SUBJECT: ISSUANCE OF AMENDMENTS RELATED TO TUSP SECTION 5.0  
(TAC NOS. M90417, M90418, M90419 AND M90420)

ATTACHMENT TO LICENSE AMENDMENT NOS. 135 AND 129

ATTACHMENT TO LICENSE AMENDMENT NOS. 156 AND 152

SAFETY EVALUATION BY THE OFFICE OF NUCLEAR REACTOR REGULATION  
RELATED TO AMENDMENT NO. 135 TO FACILITY OPERATING LICENSE NO. DPR-19,  
AMENDMENT NO. 129 TO FACILITY OPERATING LICENSE NO. DPR-25,  
AMENDMENT NO. 156 TO FACILITY OPERATING LICENSE NO. DPR-29,  
AND AMENDMENT NO. 152 TO FACILITY OPERATING LICENSE NO. DPR-30  
COMMONWEALTH EDISON COMPANY  
AND  
IOWA-ILLINOIS GAS AND ELECTRIC COMPANY  
DRESDEN NUCLEAR POWER STATION, UNITS 2 AND 3  
QUAD CITIES NUCLEAR POWER STATION, UNITS 1 AND 2  
DOCKET NOS. 50-237, 50-249, 50-254 AND 50-265

**FIGURE 5.1.B-1**  
**LOW POPULATION ZONE**

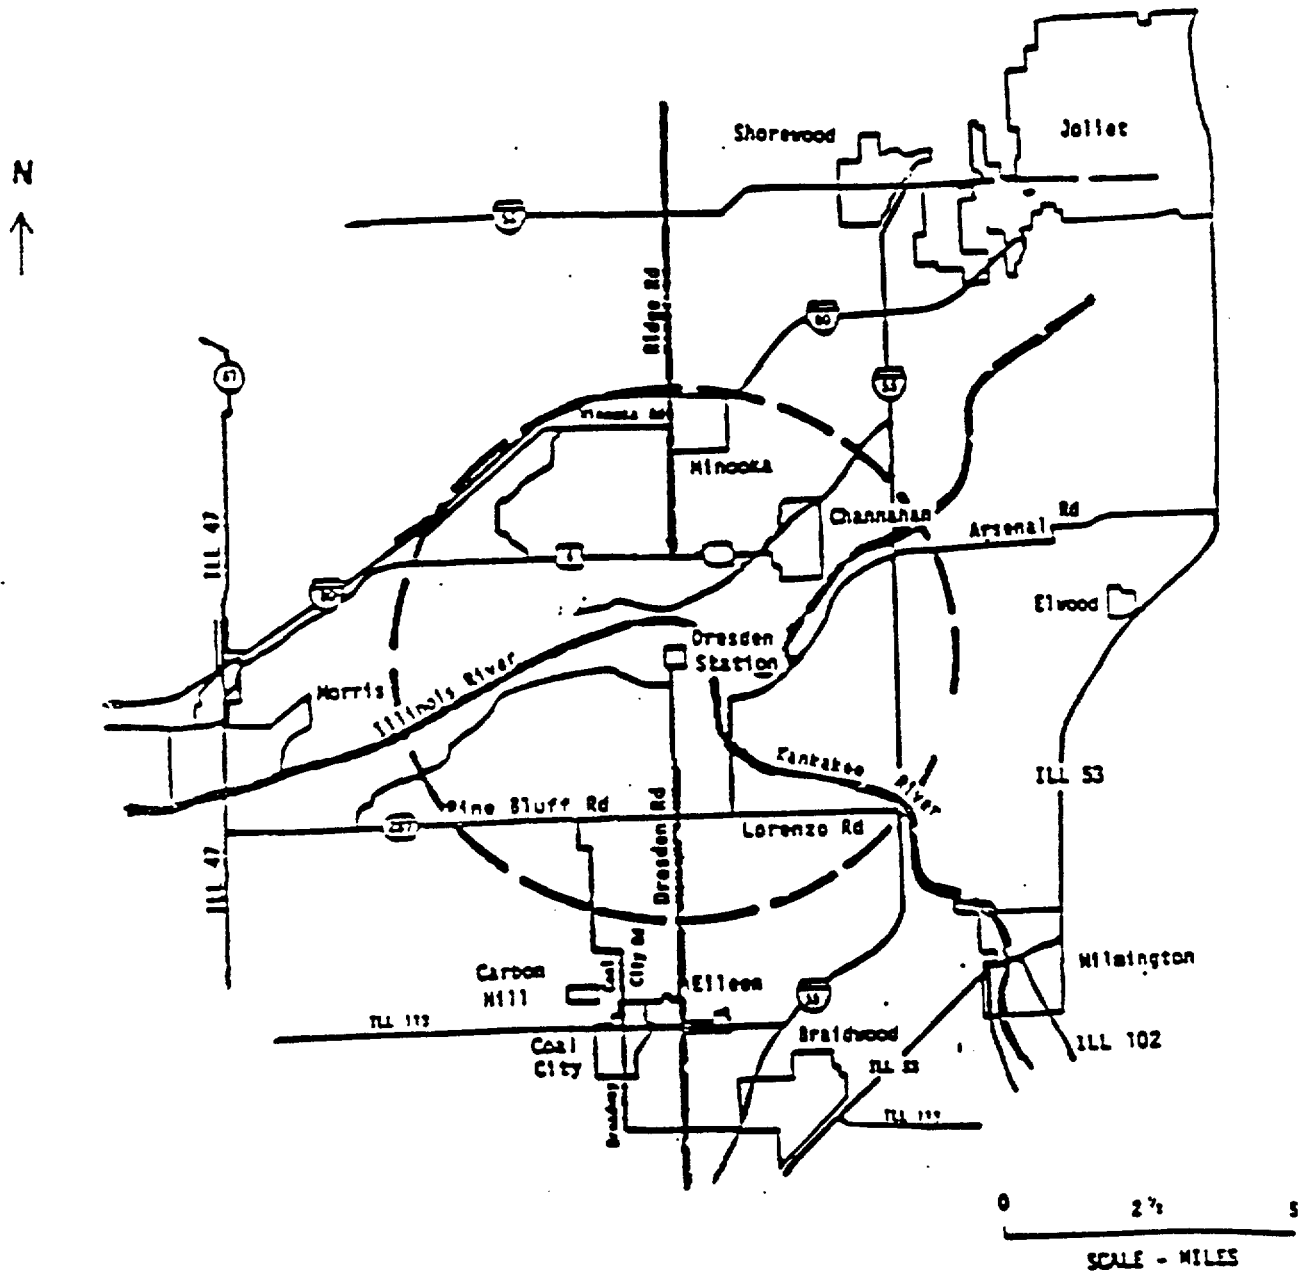
Proposed TSUP Section 5.1, "Site," incorporates the guidelines of STS Section 5.1 and all existing TS requirements from Section 5.1 for both Dresden and Quad Cities. Plant-specific Figures 5.1.B-1, Low Population Zone are consistent with the safety analysis for the plant. The proposed Figures 5.1.B-1 provided in the December 15, 1993, submittal were unclear. This item is left as an open item contingent upon correction in the TSUP cleanup amendment. In addition, the licensee did not include the STS figure concerning the exclusion area. This item is also left as an open item. Based on discussions between the NRC staff and ComEd, Figure 5.1.A-1 for the Exclusion Area will be added in the cleanup amendment. The location and/or description of the Meteorological Tower will be added to Figure 5.1.A-1.

1. Figure 5.1.B-1, Low Population Zone
2. Figure 5.1.A-1, Exclusion Area
